Office of Utilities Regulation

**Cost Model for Mobile  
Termination Rates – The  
Decision on Rates**

**Determination Notice**

**DOCUMENT NUMBER:** TEL2013001\_DET001

**Figure 1: Evolution of the MTR based on pure LRIC with adjusted tilted annuities**

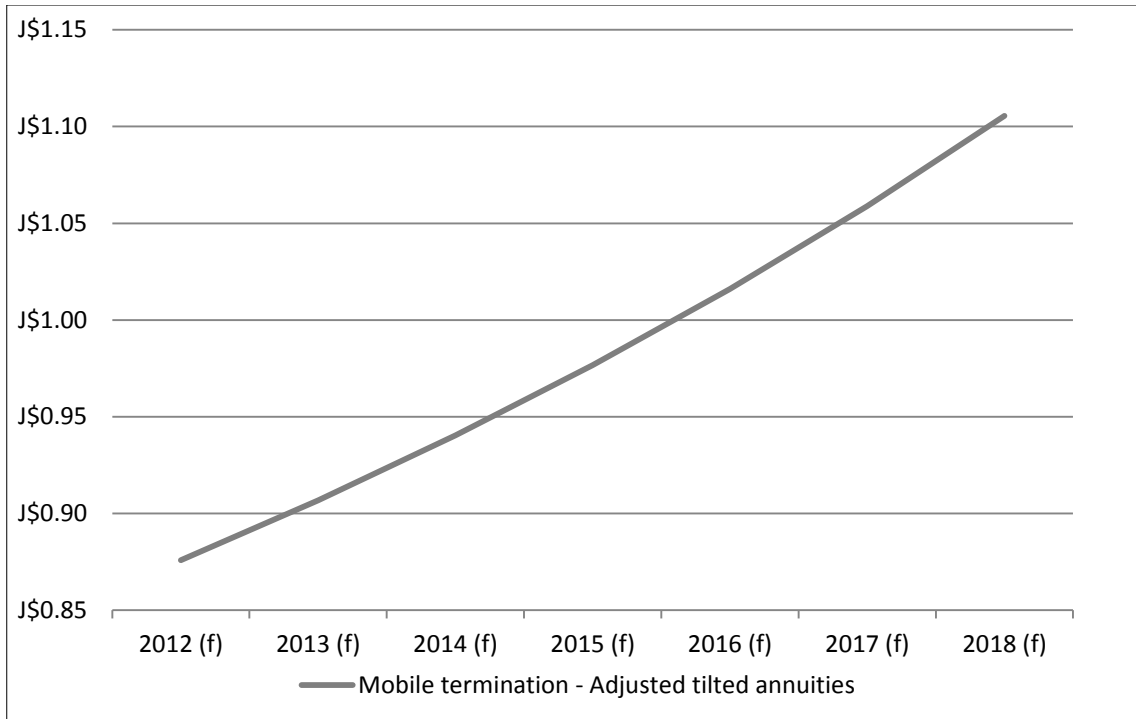
6.6 The yearly approach adopted in the draft model is a requirement defined in the Determination Notice titled “Cost Model for Mobile Termination Rates” Document No: TEL2012001\_DET001 published July 24, 2012. Therefore this approach will not be changed. Furthermore, the yearly approach has no impact on the behavior of the pure LRIC results except if the number of assets were decreasing,

which is not the case. The erratic behavior observed by DIGICEL results from the threshold effects inherent to cost modelling. However, MTRs are set following the pure LRIC with adjusted tilted annuities method, which evolves in a smoother way.
